From: Sacks, Victoria [Sacks.Victoria@epa.gov]
Sent: 10/15/2020 8:03:38 PM
To: Gravelding, Mark [Mark.Gravelding@arcadis.com]
CC: Putnam, Lauren [Lauren.Putnam@arcadis.com]; Singerman, Joel [Singerman.Joel@epa.gov]
Subject: RE: Lower Ley Creek - revised PDI Report - removal near LLCD13

From: Gravelding, Mark <Mark.Gravelding@arcadis.com>
Sent: Wednesday, October 14, 2020 4:32 PM
To: Sacks, Victoria <Sacks.Victoria@epa.gov>
Cc: Putnam, Lauren <Lauren.Putnam@arcadis.com>
Subject: RE: Lower Ley Creek - revised PDI Report - removal near LLCD13

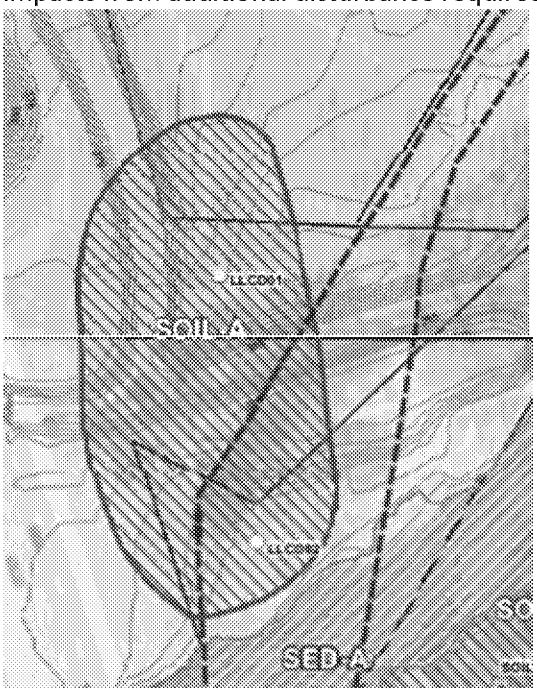
We apologize for not bringing this up at the same time, but this morning one of the Respondents brought up that SOIL-A may be a similar situation:

- Within / adjacent to the City of Syracuse landfill;
- <1 mg/kg PCB results;
- The historical metals results are generally below the screening criteria, with the exception of arsenic, copper, lead, mercury, and zinc, which are not substantially above the screening criteria:

- Boring Logs from samples collected at LLCD01 and 02 specify presence of anthropogenic material indicative of landfill waste not dredge spoils and as such should not be considered as part of the Lower Ley Creek Subsite; and
- The location of SOIL-A is fairly isolated and separated from the remainder of the removal areas, and the negative impacts from additional disturbance required to remediate outweighs the benefit of removing the soil.

Sorry for the last minute request but if you agree, we would like to include the above proposal in the revised report to be submitted tomorrow; however, if you disagree let us know if you would like to discuss ahead of the Thursday deadline or if we should not include it.

Please continue to include SOIL-A in the report. If you would like to add some text explain that this area is under consideration for reduction, that is fine. We will further define the limits of excavation in the RD.

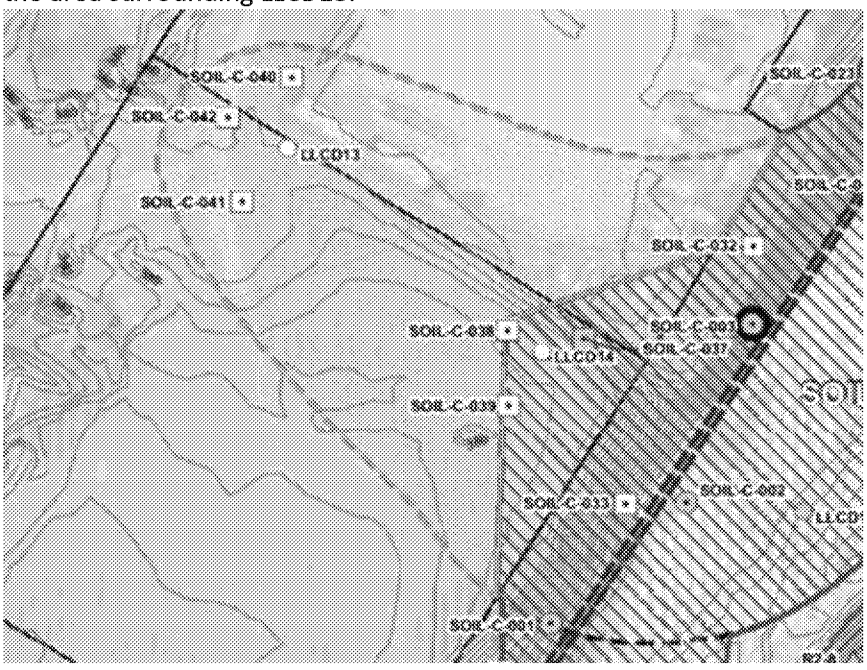
Some boring logs recently became available to one of our clients (as part of a separate investigation) that highlight the overlap of some of the Lower Ley Creek Subsite removal area with the former City of Syracuse landfill area, specifically in the area surrounding LLCD13.

This is an area we proposed in the May 2020 PDI Summary Report be removed from the remedy, but on our conference call a couple weeks ago that we agreed to highlight this "airplane tail" area to *potentially* be removed from the remedy based on the results of future metals sampling. In light of additional information and discussions with the Respondents, we again propose the area around LLCD13 in SOIL-C as a removal extent reduction area, and without the need for future sampling, based on the following conclusions:

- The area is solidly within the former City of Syracuse landfill area, and there were previous discussions with EPA that although the Respondents would need to address PCBs found in dredge spoils/flood residue that had been deposited on top of landfilled waste they would not have to chase after PCBs (or other constituents) contained in landfilled waste;

- The PCBs results from PDI sampling are less than 1 ppm;
- PDI soil sampling results provide supporting information that this area is not part of a former dredge spoil area – specifically samples Soil-C-039, Soil-C-038, and Soil-C-032 are less than 1 for PCBs and support the belief that the "airplane tail" is not part of the Soil C dredge spoil deposit and the boundary as presented in the ROD should not have been extended to encompass LLCD13 .

- The historical metals results are generally below the screening criteria, with the exception of copper, lead, mercury, nickel, and zinc, which are not substantially above the screening criteria (see Attachment 3 of Respondents' August 27, 2020 comment response);

- Field notes from samples collected at SOIL-C-037 through -042 specify presence of anthropogenic material such as asphalt, concrete, plastic, brick, glass generally indicative of landfill waste and as such should not be considered as part of the Lower Ley Creek SIte;

- The location of LLCD13 is fairly isolated and separated from the remainder of the removal areas, and the negative impacts from additional disturbance required to remediate outweighs the benefit of removing the soil.

Thank you for the updated information regarding the area surrounding LLCD13. EPA and DEC concur that this area may be reduced in the PDI Data Summary Report. Please justify the logic for reducing the area in the body of the report and

include information showing the boundaries of the former City of Syracuse landfill (in relation to those 4 borings of interest), boring logs showing anthropogenic material in the area, and field notes of the collected samples SOIL-C-038 through -042.
